# Design Guidelines Issues Part 1

The Trails at Carmel Mt Ranch - Project No. 652519 Design Guidelines (11 MB)

## Design Guidelines Issues Part 2

### ***Buffers between existing homes and new buildings***

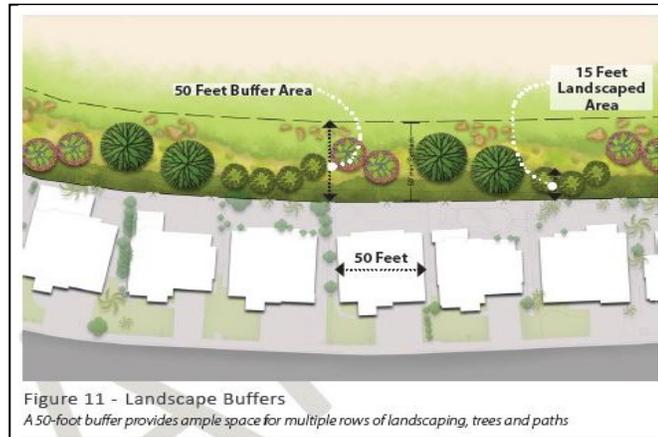
Figure 11 – Design Guidelines Page 14 – The caption says "A 50-foot buffer provides ample space for multiple rows of landscaping, trees and paths" The buffer area shows planted landscaping only. It does not show the buildings allowed to be just beyond the buffer area, or the trails, carports, recycle bins, parking areas, or roads. Elsewhere in the guidelines it states that any of those items could be present. (See "The Fine Print" below)

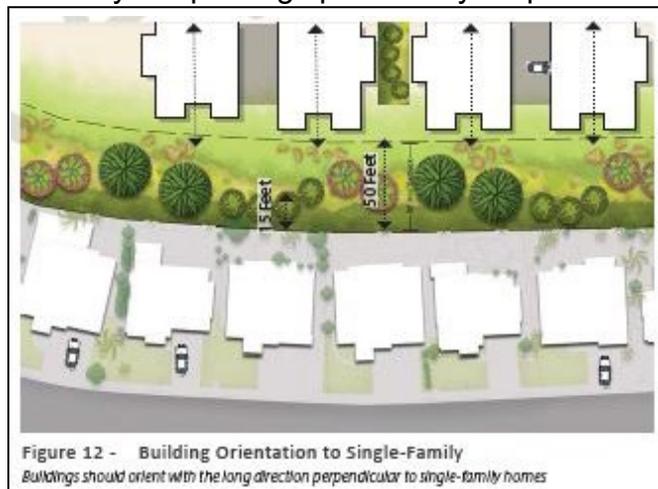
Figure 12 – Design Guidelines Page 14 – This picture does show the buildings just beyond the buffer area, but there are still none of the paths, roads, or parking areas that are likely to be present. The Landscape Plans (Complete Plan Set sheets 43 through 56) show more details of the buffer area planting and most units have at least one area with less than 10' of actual landscaping shown. This suggests that hardscape such as driveways or parking spaces may be planned for those areas.
